# SERVICE LETTER

**SUBJECT: OVERVIEW REGARDING TORQUE LIMITER, FUEL CONTROL UNIT AND OTHER ENGINE STARTING RELATED TECHNICAL INFORMATION**

Date: May 7/1997

**7. ACTIONS -- SEE FLOW CHART**

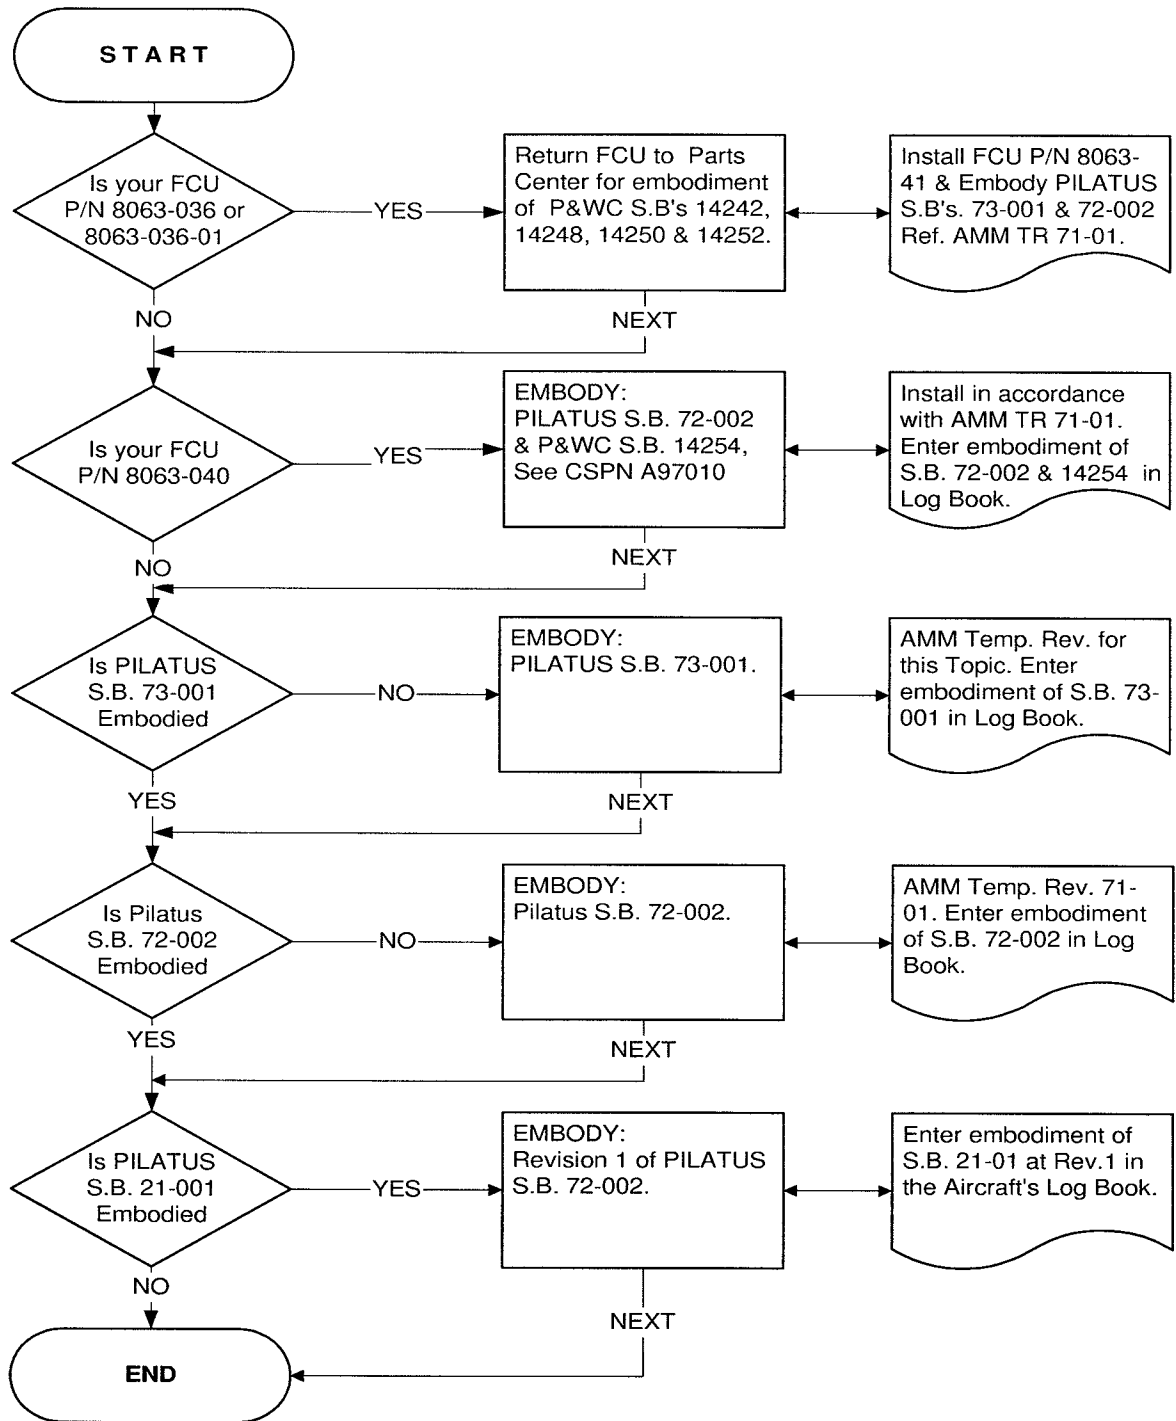
Customers that embodied Pilatus SB 21-001 should incorporate revision 1 of SB 21-001 as soon as possible.

Customers starting engines in accordance with the AMM procedure should use F. I. when the oil temperature is below +5°C.

Customers with an FCU P/N 8063-036 or 8063-036-01 should return it to PWC for incorporation of PWC SB's 14242, 14254, 14248, and 14250 (see CSPN A97011). In return, they will receive an exchange FCU P/N 8063-041. You should then install this FCU and simultaneously embody Pilatus SB 73-001 and 72-002 in accordance with TR 71-01 in the AMM. Operation of the engine will thereafter follow the latest AFM revision and TR for the torque limiter.

Customers with FCU P/N 8063-040 should embody Pilatus SB 72-002 (including PWC SB 14254, see CSPN A97010) in accordance with the AMM's TR 71-01. . Operation of the engine will thereafter follow the latest AFM revision and TR for the torque limiter.
